ADDENDUM #1 – APRIL 1, 2026

RE: COQUILLE INDIAN HOUSING AUTHORITY
Single Family Residence Project & Duplex Building Project
Project #24.041

FROM: HGE ARCHITECTS, Inc.
333 South 4th Street
Coos Bay, Oregon 97420
541-269-1166

FIRE & SOUND WALL

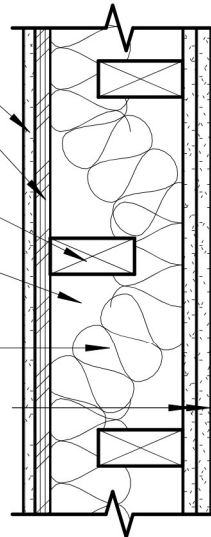
- a. **Sheet A1.1 ECM & Site Plan:** REPLACE with attached revised Sheet. Revision includes reduced scope of site grading & erosion control. Add note "4 INCH SAN. SEWER, CONNECT TO (E) SEWER LATERAL W/ CLEAN OUT".
- b. **Sheet A1.2 Erosion Control Plan & Details:** REPLACE with attached revised Sheet. Revision includes reduced scope of site grading & erosion control.
- c. **Sheet A2.1 Floor Plan, Details, Schedules, Detail 2 - Fire & Sound Wall:** REPLACE with the below revised Detail. Revised to show STC-50 and 1-hr rated assembly, GA WP 3371.

STC 50, 1-HR RATED

- 5/8" TYPE X GYP. BD.
- 1/2" STRUCTURAL SHEATHING
- 2x4 STUDS @ 8" O.C.
- 2x6 TOP & BOTTOM PLATES
- 3" MINERAL WOOL BATT
WOVEN BETWEEN STUDS
- (2) LAYERS 5/8" TYPE X GYP. BD.

NOTE: EXTEND FROM
SLAB TO UNDERSIDE
OF ROOF SHEATHING

REFERENCE GA WP 3371

1 FLOOR PLAN - 504 ADAPTABLE UNIT
1/4" = 1'-0"

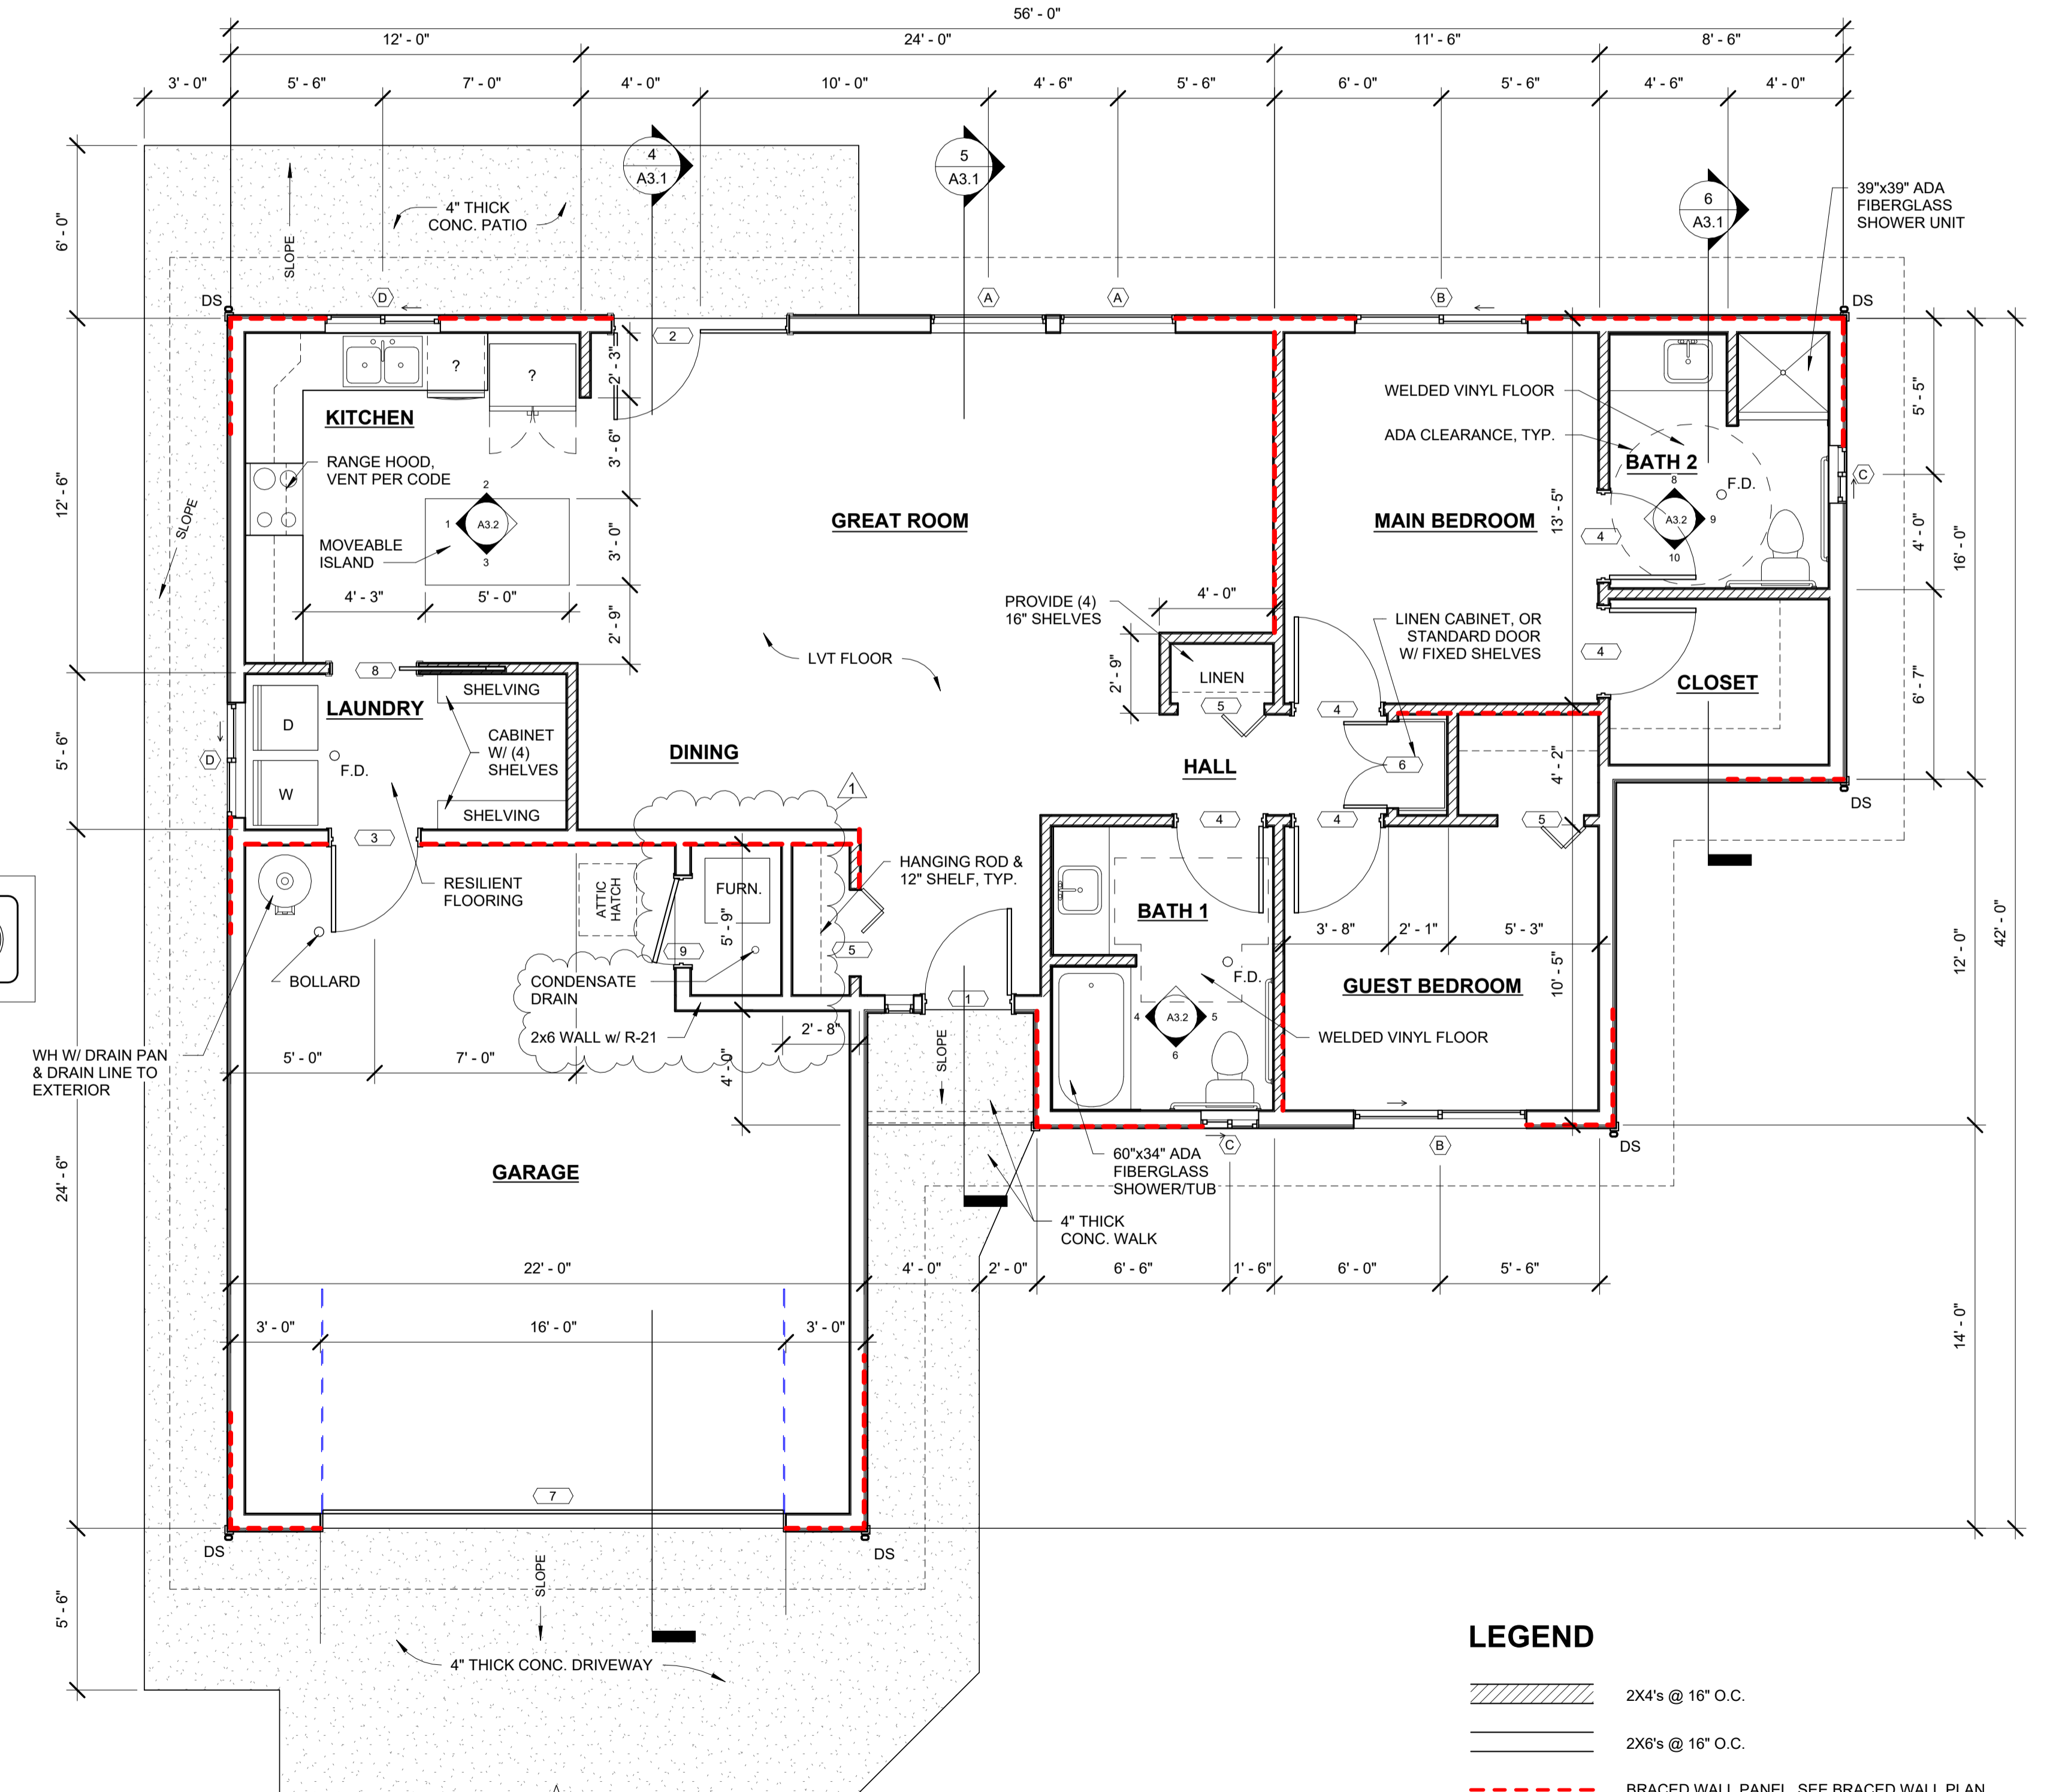
1. *Single Family Residence:*
 - a. **Sheet A2.1 Floor Plan, Details, Schedules:** REPLACE with attached revised Sheet. Revision includes adding a furnace enclosure to the garage.
 - b. **Sheet A2.2 Braced Wall Plan:** ADD attached Sheet in its entirety.
 - c. **Sheet A2.3 Foundation Plan and Details:** REPLACE with attached revised Sheet. Revision includes adding a furnace enclosure to the garage.
